ROLLING HILLS RANCH FILING NO. 2 AT MERIDIAN RANCH

A PARCEL OF LAND LOCATED IN A PORTION OF SECTION 20 & 29, IN TOWNSHIP 12 SOUTH,
RANGE 64 WEST OF THE 6TH PRINCIPAL MERIDIAN

Final Plat Drawings_v2.pdf Markup Summary

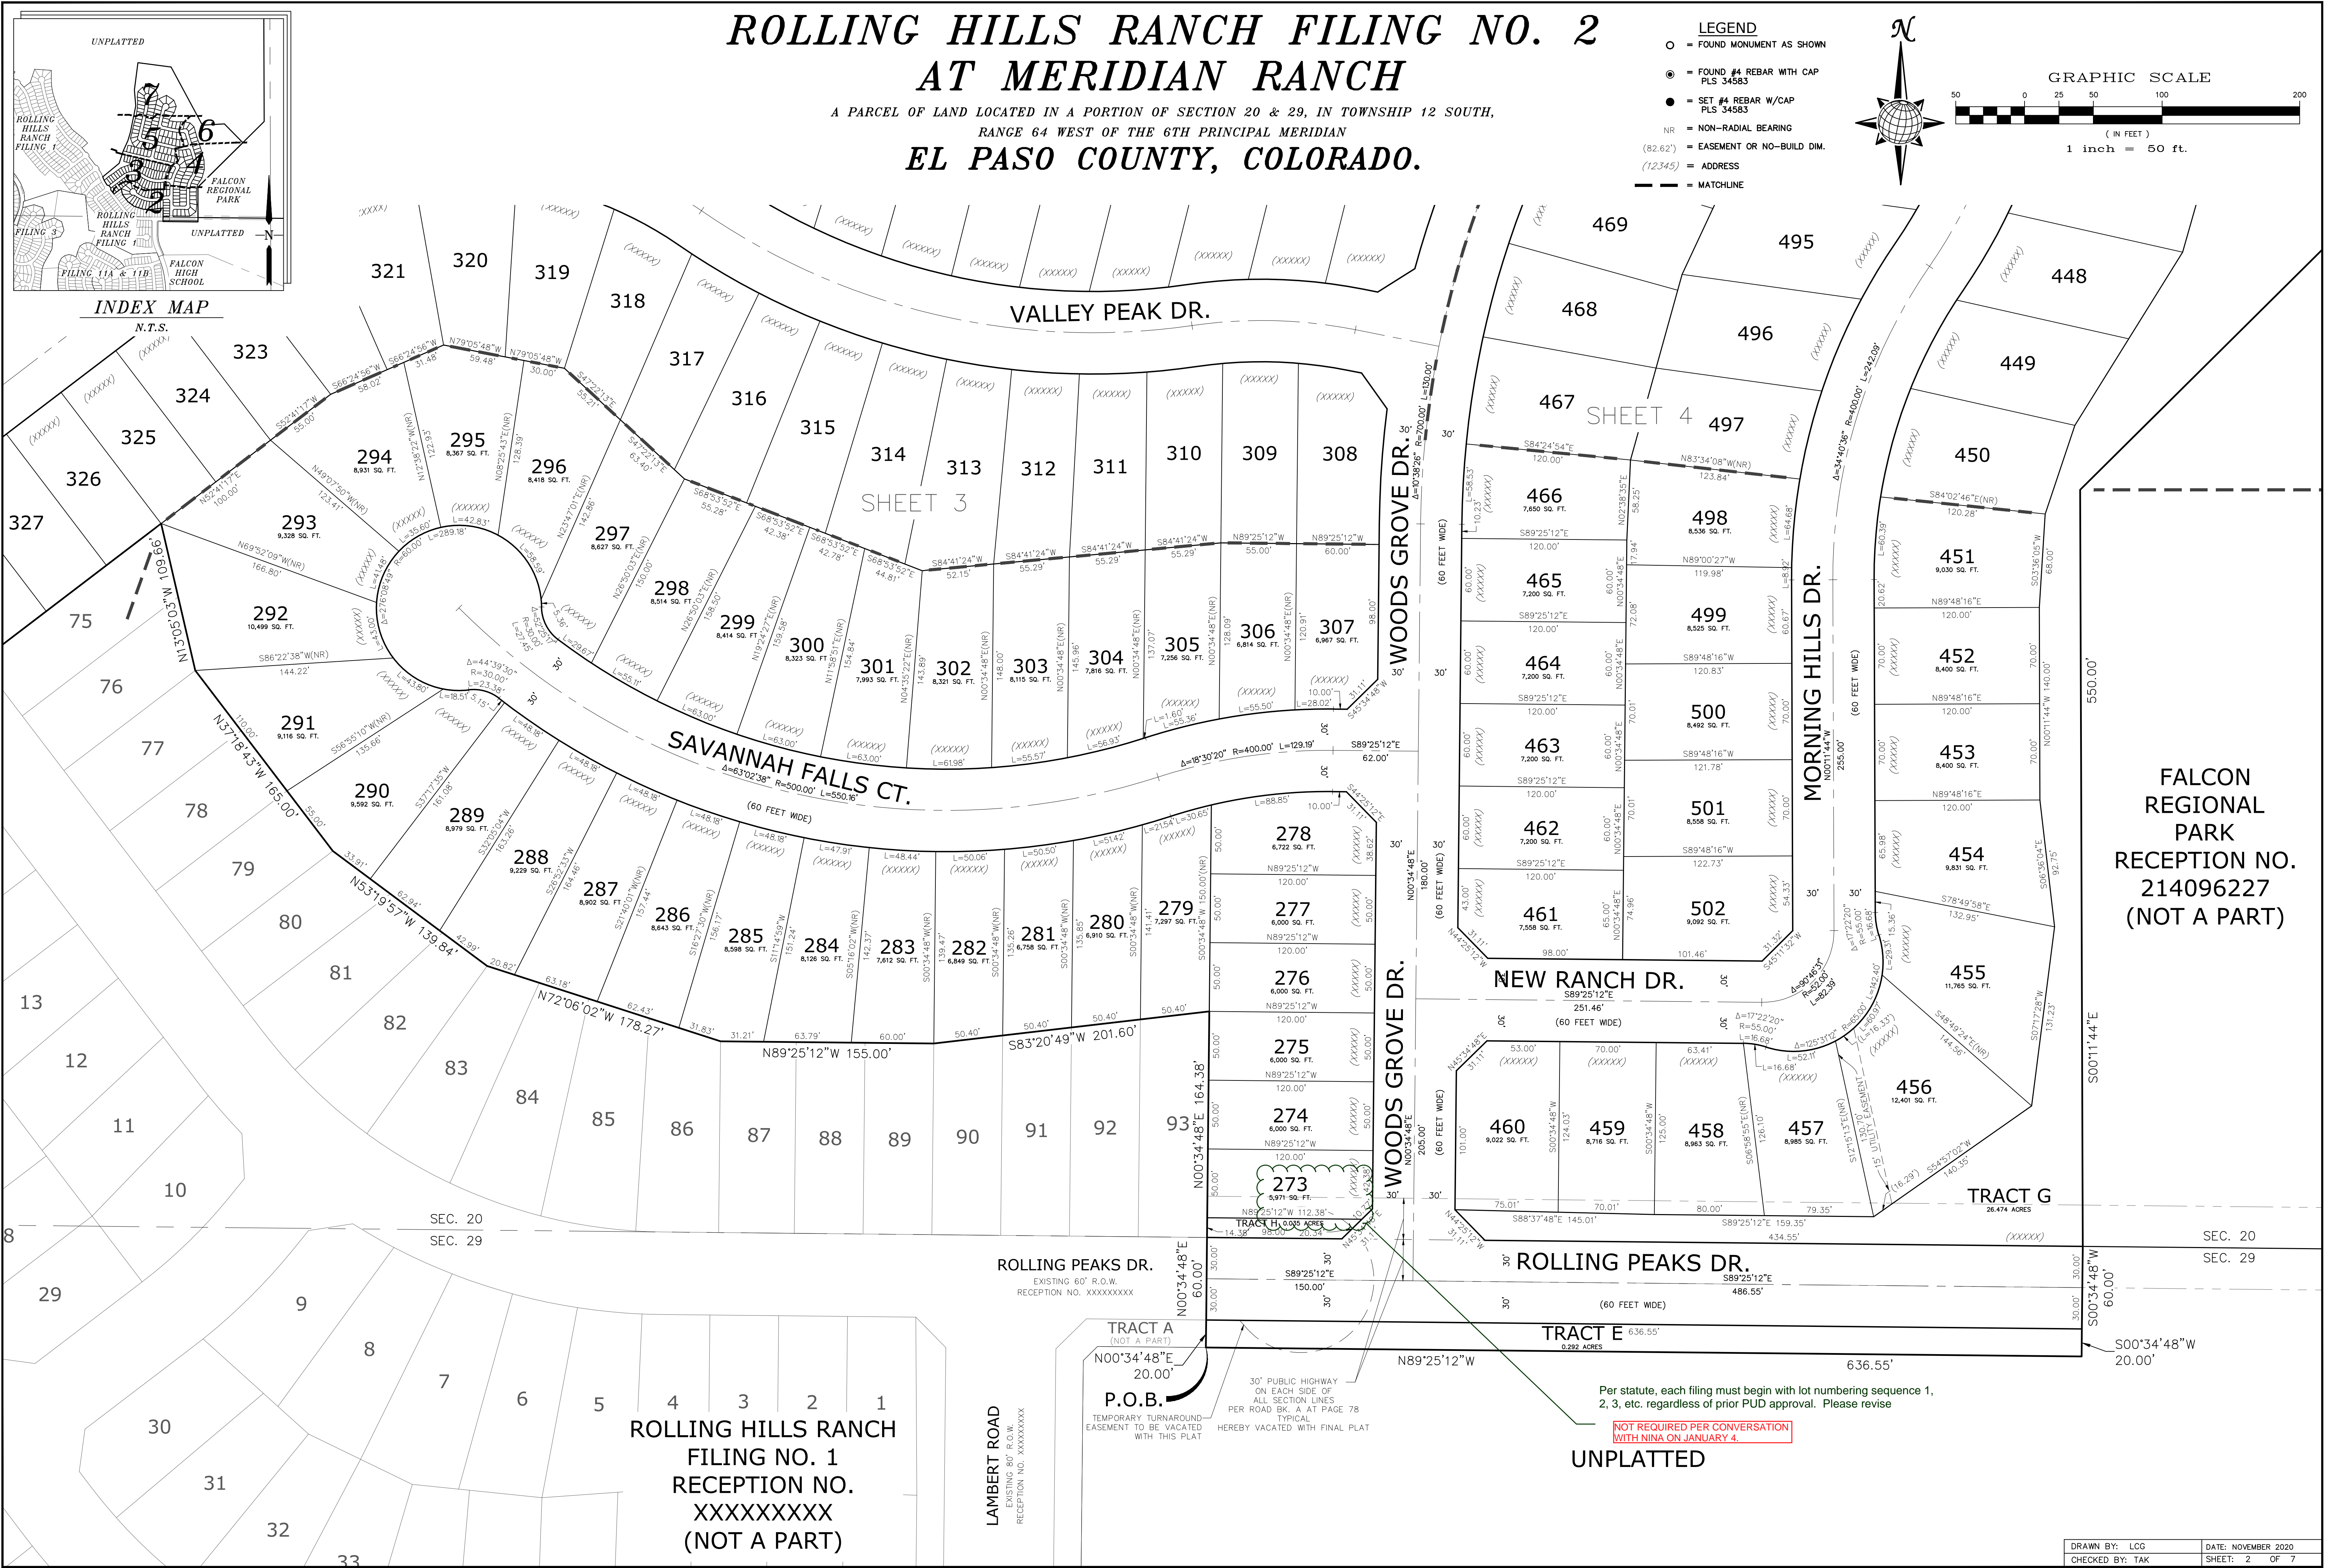
Final Plat will be approved administratively and this signature block is not required. Please remove.

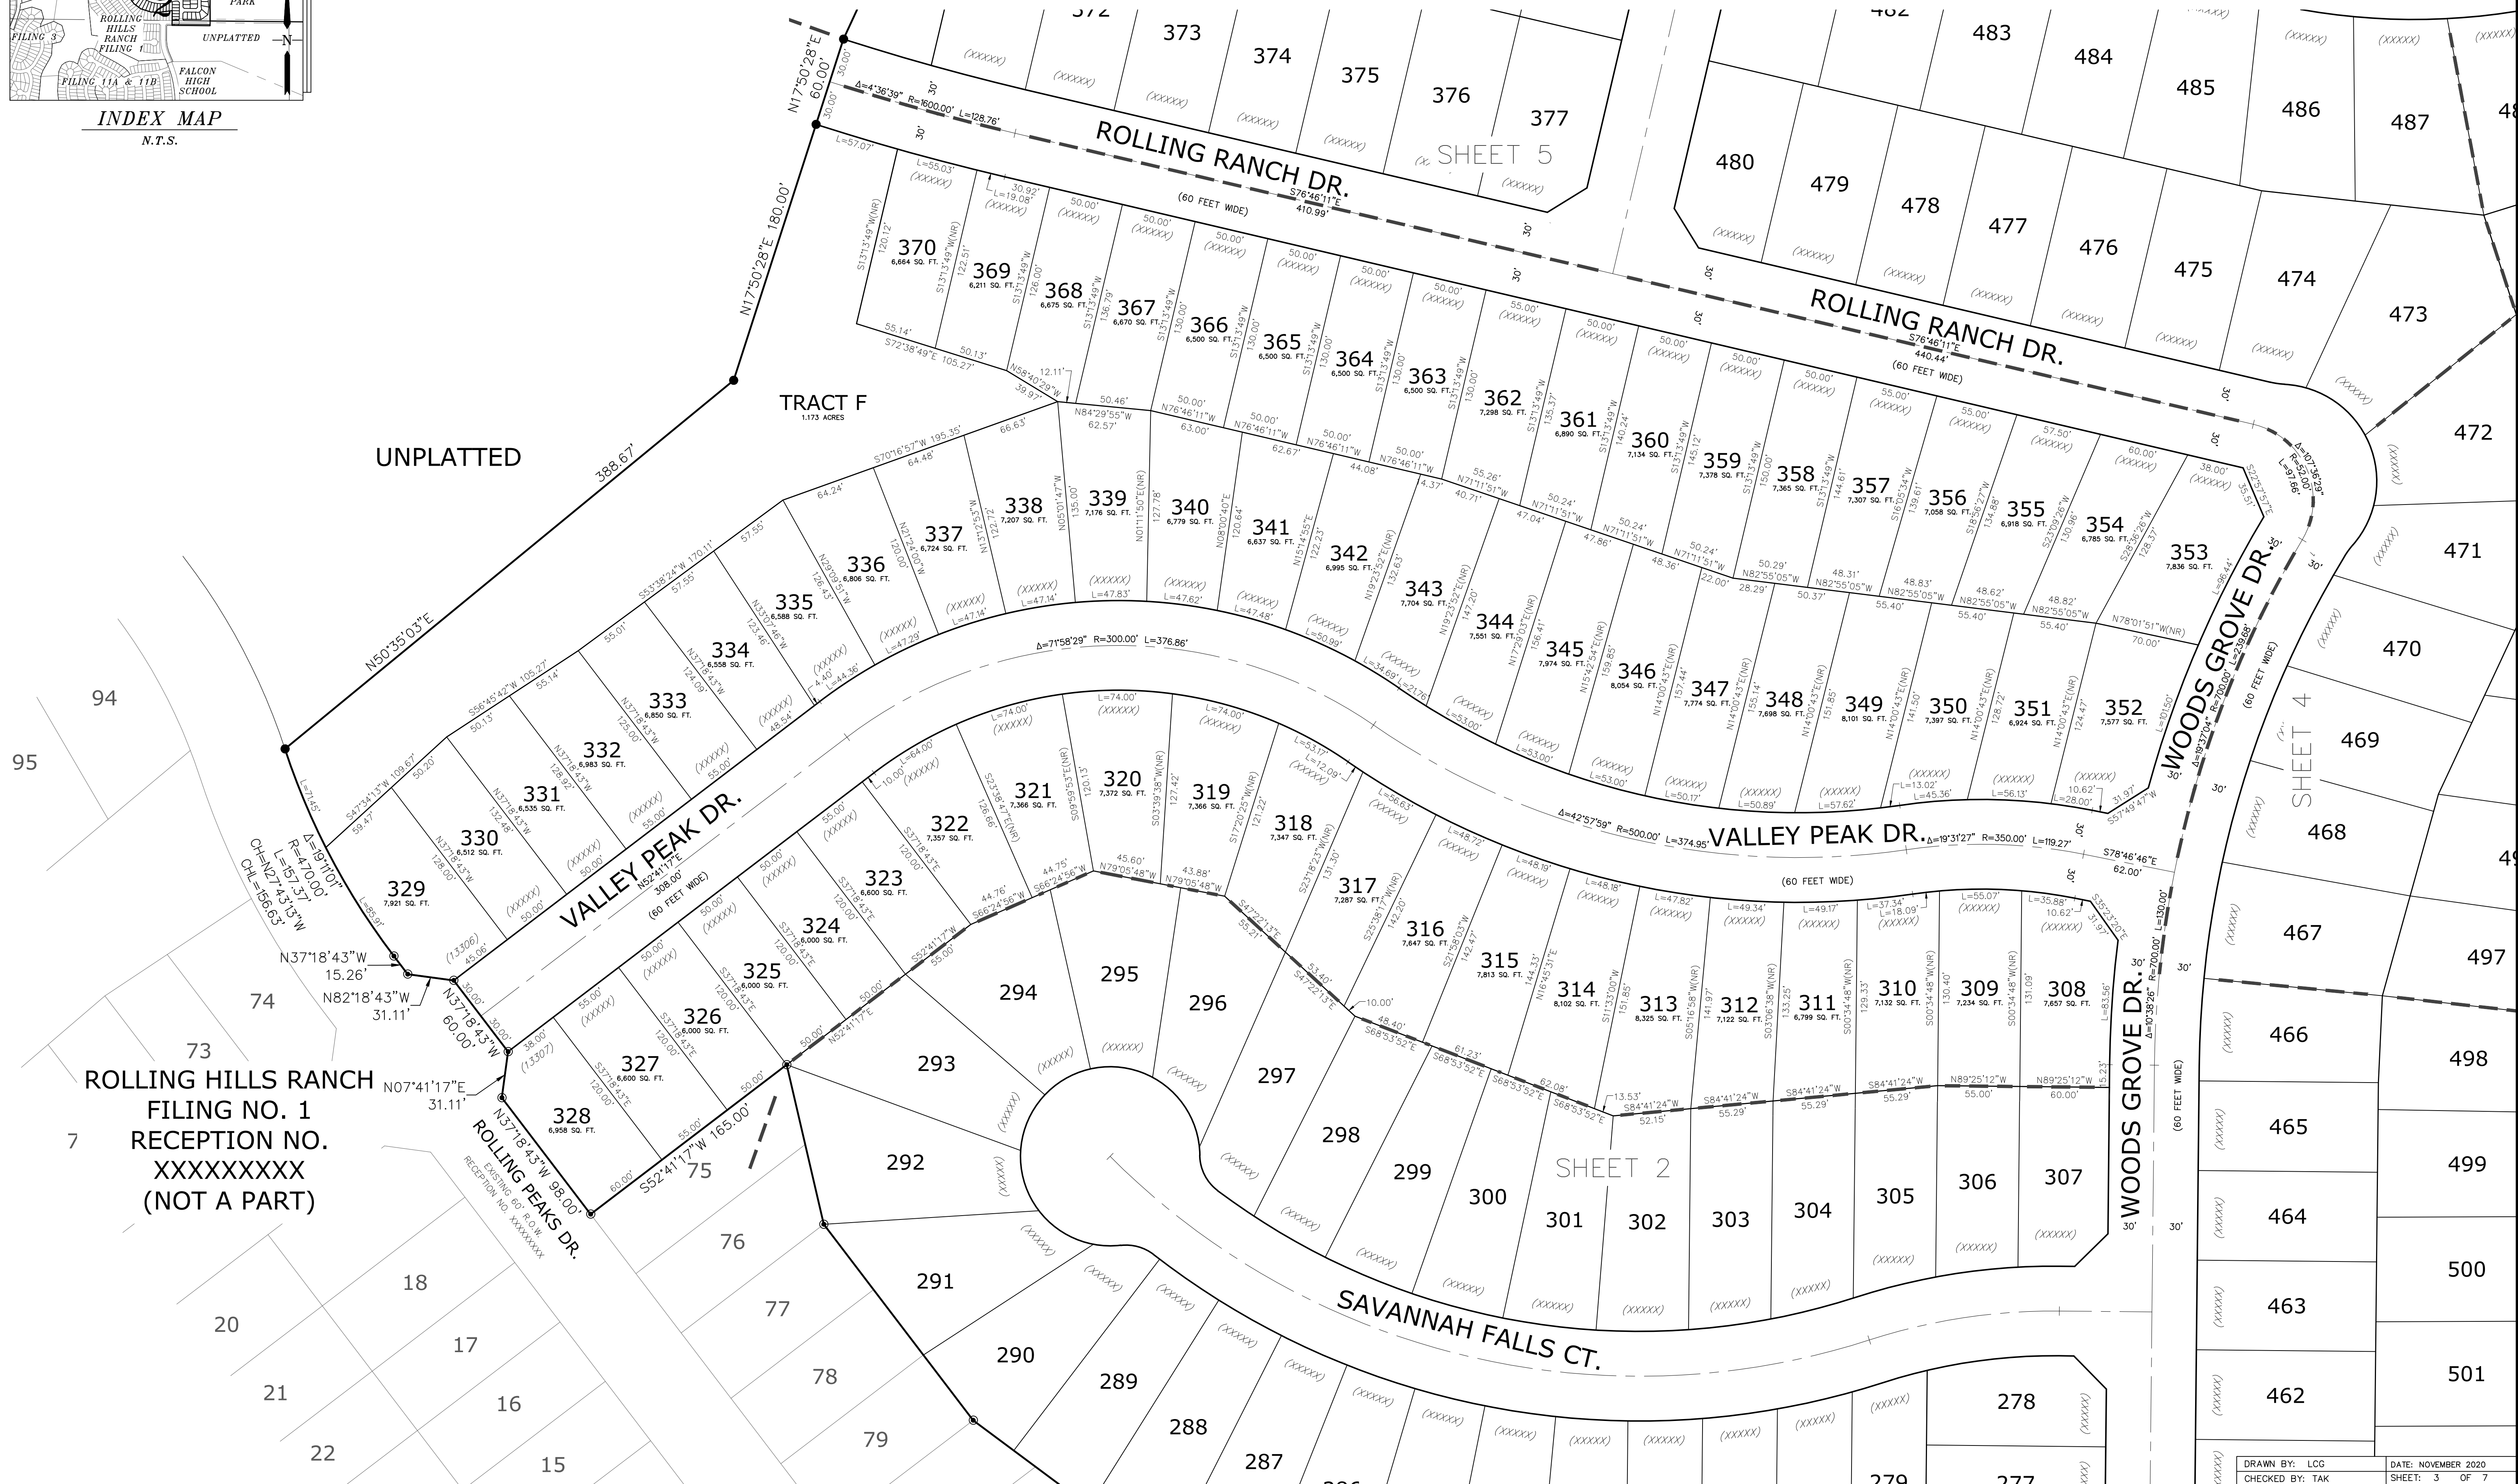
Per statute, each filing must begin with lot numbering sequence 1, 2, 3, etc. regardless of prior PUD approval. Please revise
